STAFF RECOMMENDATION 1818 Wildwood Avenue December 18, 2013

Application: New construction-infill
District: Belmont-Hillsboro Neighborhood Conservation Zoning Overlay
Council District: 18
Map and Parcel Number: 11704013600
Applicant: Manuel Zeitlin, architect
Project Lead: Robin Zeigler, robin.zeigler@nashville.gov

<p>Description of Project: The applicant proposes to construct a side-by-side duplex on a vacant lot.</p> <p>Recommendation Summary: Staff recommends approval with the conditions that:</p> <ul style="list-style-type: none">• The applicant obtains final approval from staff of the roof color;• The brick not be painted; and• The applicant obtains final approval from staff of the materials for the foundation, driveway, walkway, cladding, vehicular and pedestrian doors, trim and railings materials. <p>With these conditions, the project meets the design guidelines for new construction in the Belmont-Hillsboro Neighborhood Conservation Zoning Overlay.</p>	<p>Attachments A: Photographs B: Site Plan D: Elevations</p>
--	--

1 SITE PLAN
1" = 20'-0"

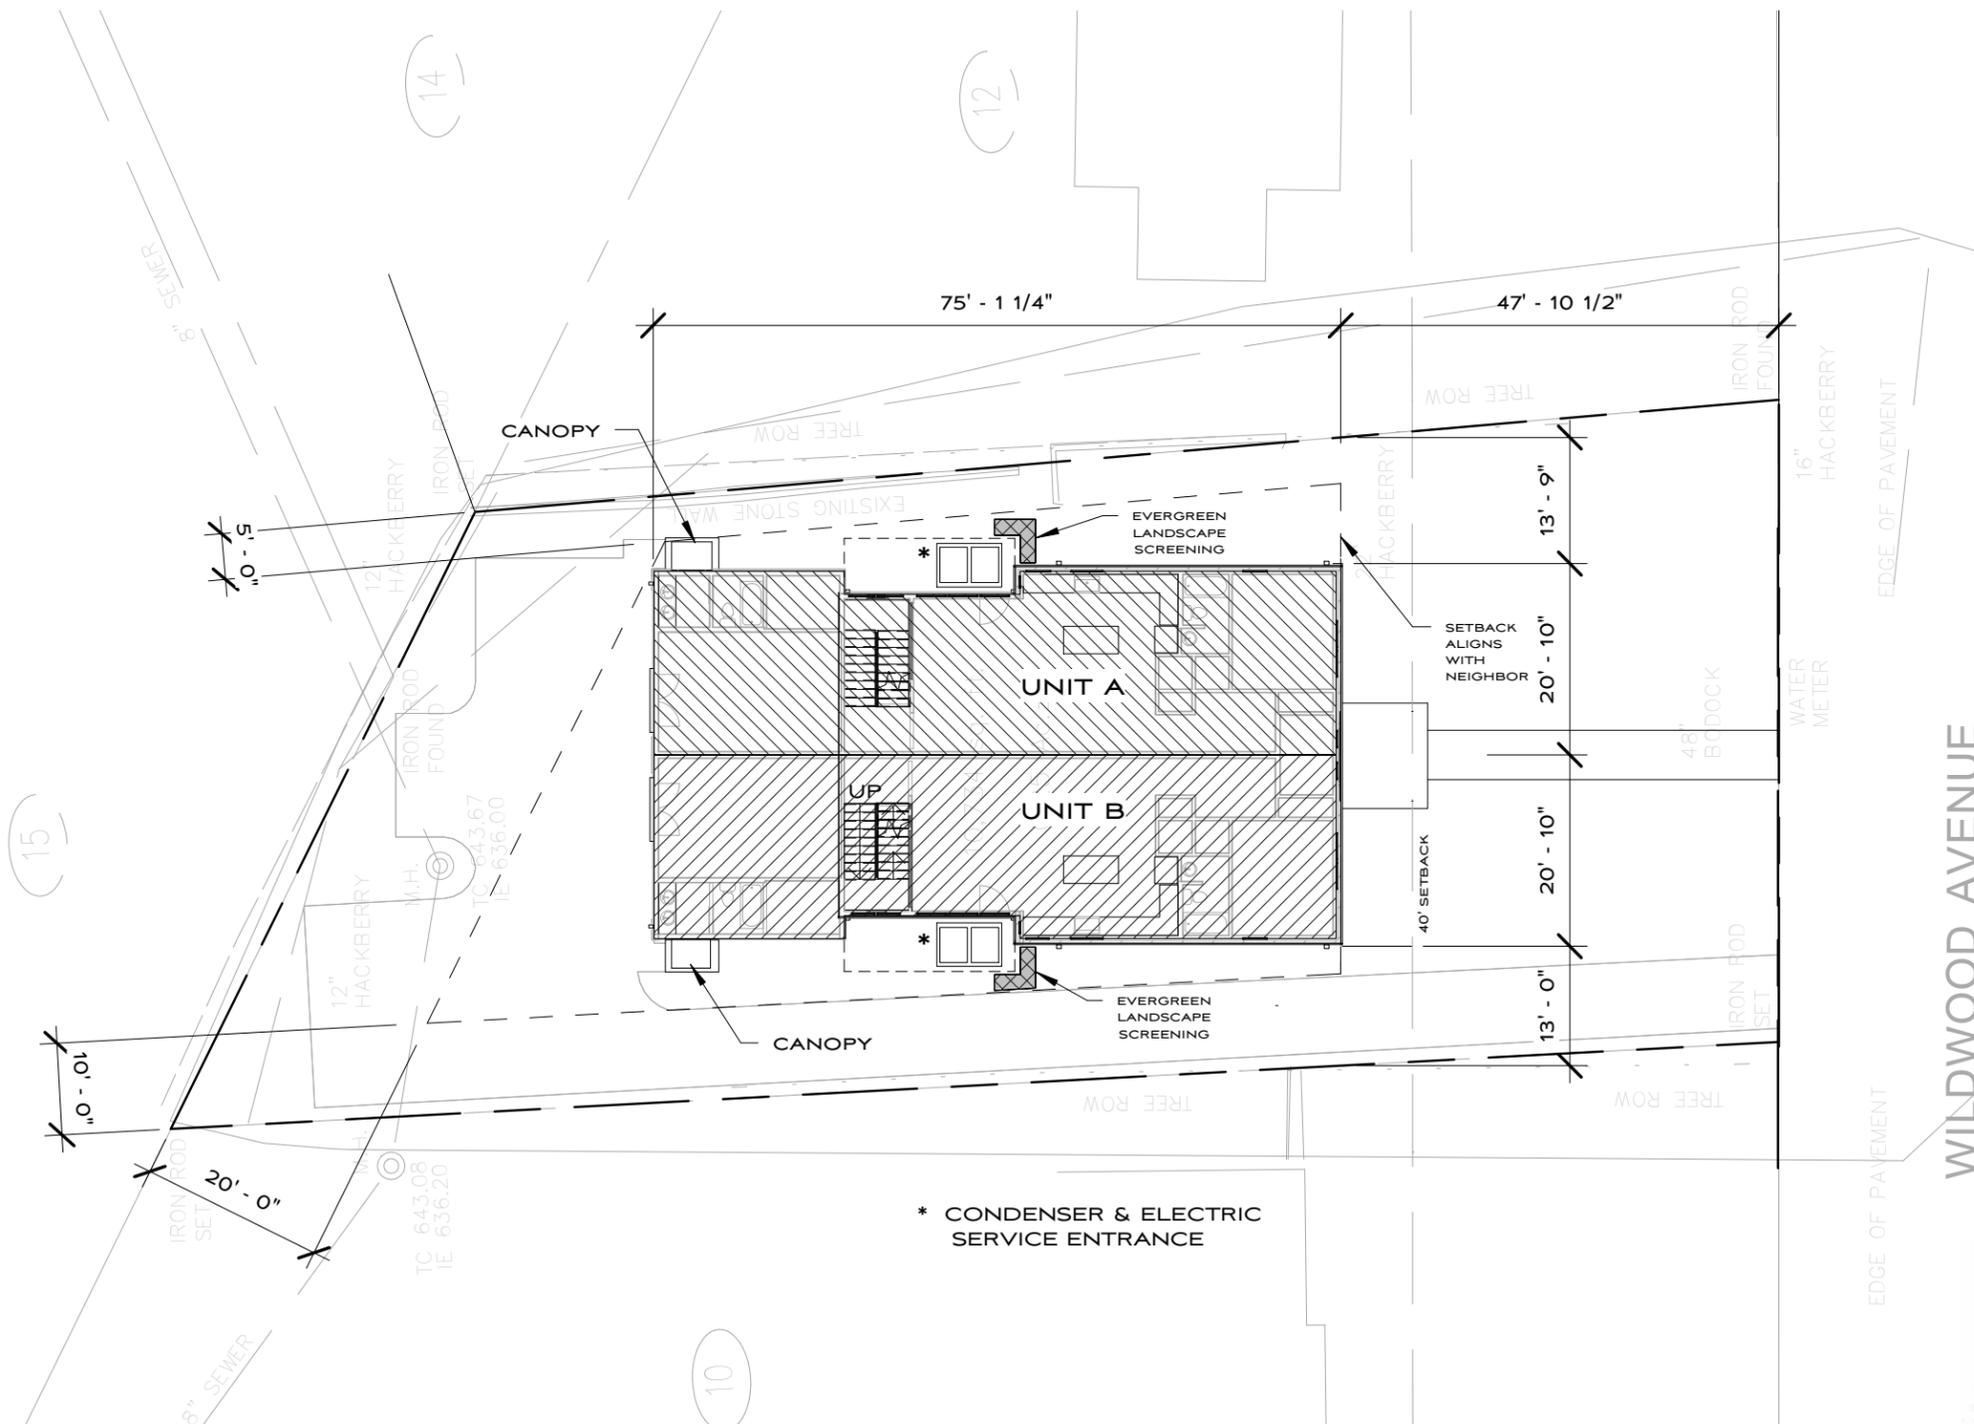
Setback & Rhythm of Spacing: The house is slightly off-center on this unusually shaped lot, similar to other homes in the area and to accommodate an existing driveway. The front setback is similar to the historic homes on either side. The project meets all bulk zoning requirements. The project meets section II.B.1.c.

Appurtenances & Utilities: The existing driveway will be extended towards the rear of the property. No other changes to the site's appurtenances were indicated on the drawings. The location of the HVACs is towards the middle of the building on each side. They are partially obscured from view with an inset of the building's side walls and will be further screened with evergreens. Landscaping is not generally sufficient as a screen since it is not permanent; however, in this case the units are primarily screened by the drop in grade and the home's side walls. The project meets section II.B.1.h.

① SOUTH ELEVATION
1/4" = 1'-0"

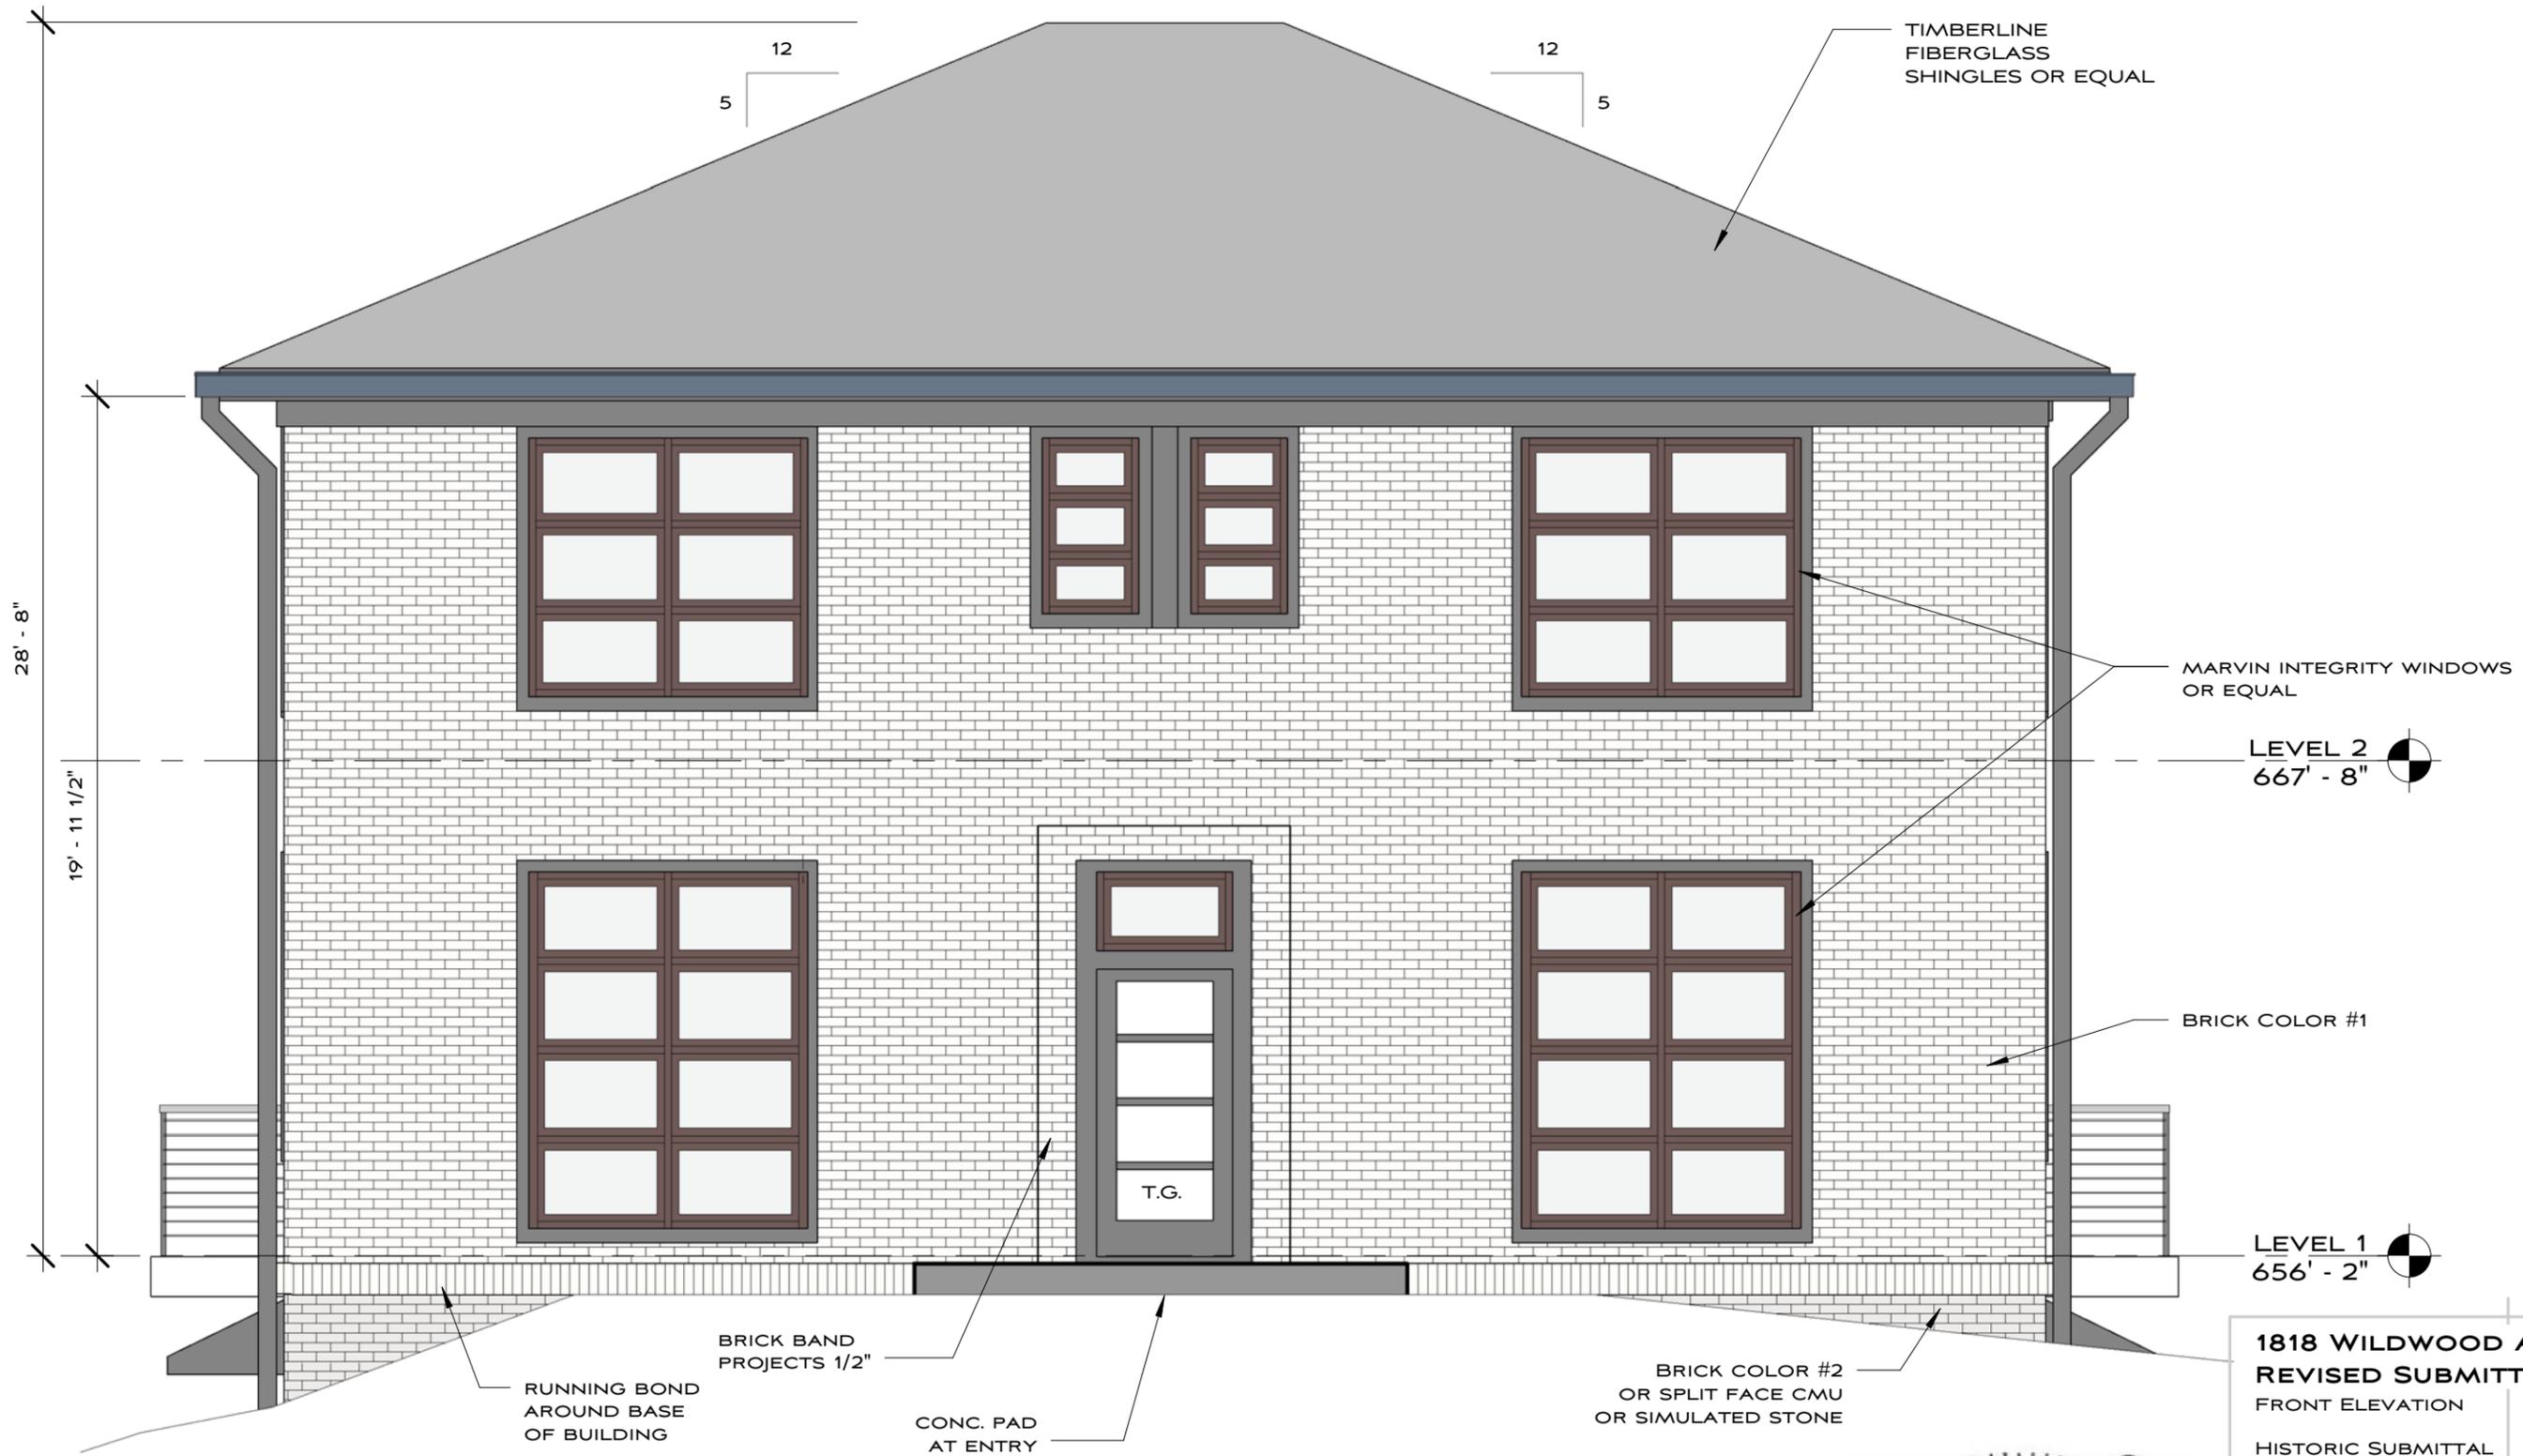
Materials: The roof will be fiberglass shingle but the color was not indicated. The siding is painted brick on the front half and cement-fiber siding panels on the rear half. Staff recommends that the brick not be painted, as historically brick was not painted. On the front half, the foundation is distinguished with a running bond and a different color brick or it may be stone or split face block, all of which are appropriate foundation materials. Staff recommends final review of foundation material. The windows are Marvin Integrity fiberglass casements and fixed windows. The materials for the vehicular and pedestrian doors, trim and railings were not indicated. The materials for the driveway and front walkway were not noted. The front stoop is concrete. Staff recommends the

applicant obtain final approval of the roof color, the brick not be painted, and the materials of the foundation, driveway, walkway, cladding, vehicular and pedestrian doors, trim and railings materials.

Roof form: The primary roof form, as seen from the street, is hipped with a 5/12 pitch, which is similar to the historic home across the street. The project meets section II.B.1.e.

Orientation: The primary entrance is oriented towards the street in a similar way as the historic home across the street with a central entrance and no porch. Historic homes in the context area often have a simplified classical door surround. This plan has a contemporary interpretation of the surround with a half inch (1/2) projection of the brick banding around the door. The vehicular entrance is an existing side driveway leading to rear-facing, attached garages. The project meets section II.B.1.f.

Proportion and Rhythm of Openings: The windows are all generally twice as tall as they are wide, thereby meeting the historic proportions of openings. Typically, double windows, like those shown, require a four to six inch (4"-6") mullion between; however, in this case the windows are not traditional double-hung windows and so the mullion is not required. There are no expanses of wall space greater than fourteen feet (14') without a window or door opening. Staff finds the project's proportion and rhythm of openings to meet Section II.B.1.g.

- The applicant obtains final approval from staff of the roof color;
- The brick not be painted; and
- The applicant obtains final approval from staff of the materials for the foundation, driveway, walkway, cladding, vehicular and pedestrian doors, trim and railings materials.
